REMARKS

PURVEY
Serial No. 09/091,157

FIG. 1

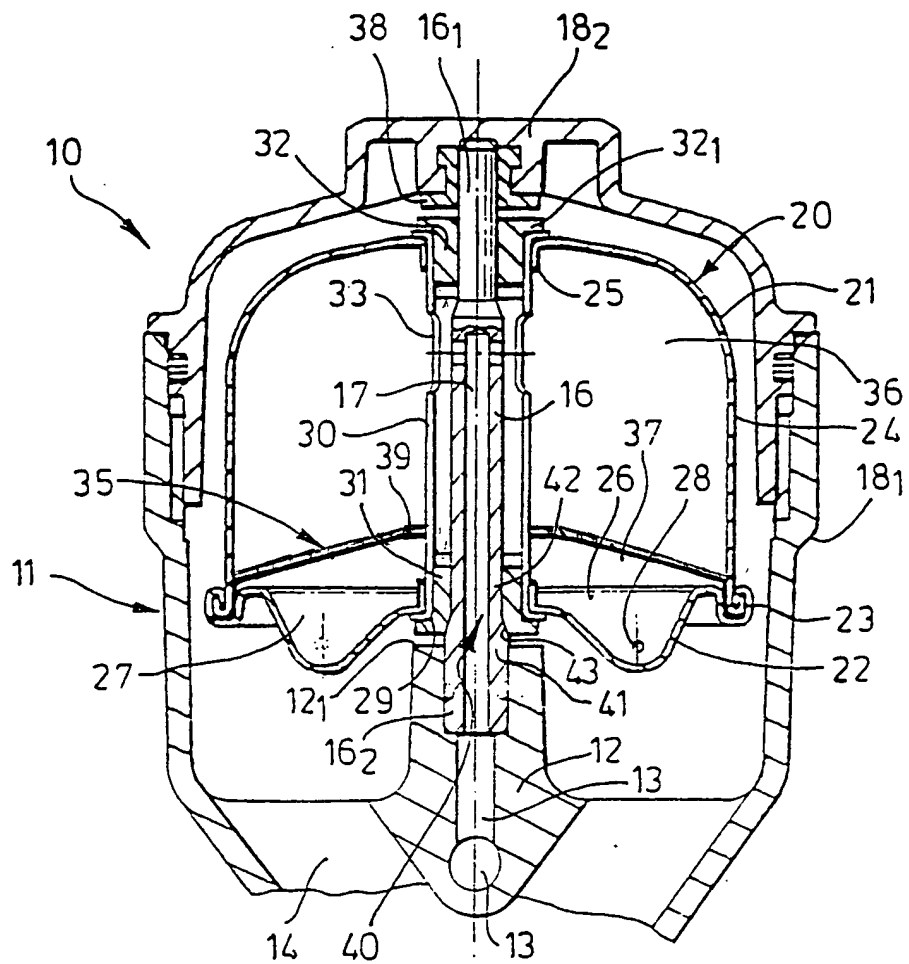
The Examiner has objected to the drawings for failing to clearly show the transfer aperture 39.

Applicant proposes to amend each of the drawing figures to more clearly show the aperture. The proposed changes are shown in red on the attached copy of the drawing figures. Approval of the proposed changes is requested. Applicant will defer formal correction to the drawings pending receipt of an Official Notice of Allowance.
